Final Product/Process Change Notification

Document #:FPCN25729XI

| Title of Change: | Wafer Fab Site Addition of onsemi, Bucheon Korea as Alternate Fab Site for ESD and Surge Protection Products and Datasheet Update |

| Item | Current Datasheet | Proposed New Datasheet |
|---|---|--|
| Figure 2 CV Characteristics | <p>ESD7205DT5G</p>  <p>Figure 2. CV Characteristics</p> | <p>ESD7205DT5G</p>  |

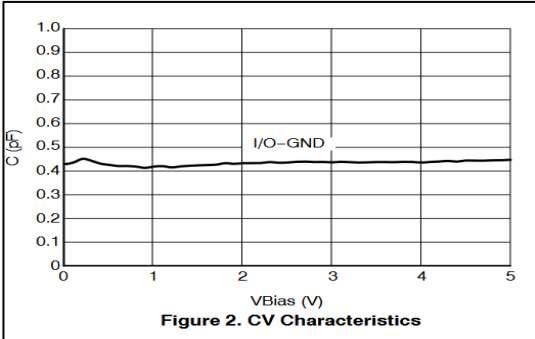
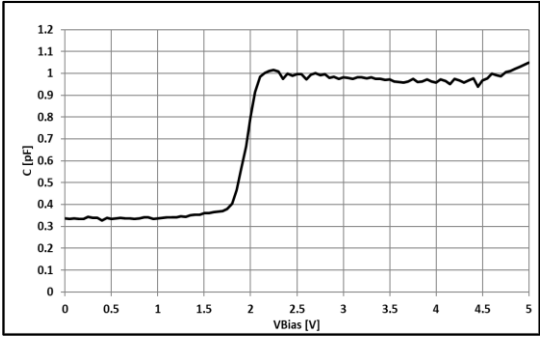
The RF insertion loss, capacitance over frequency, and IEC61000-4-2 contact ESD clamping voltage graphs will also be updated to better represent ESD7205DT5G.
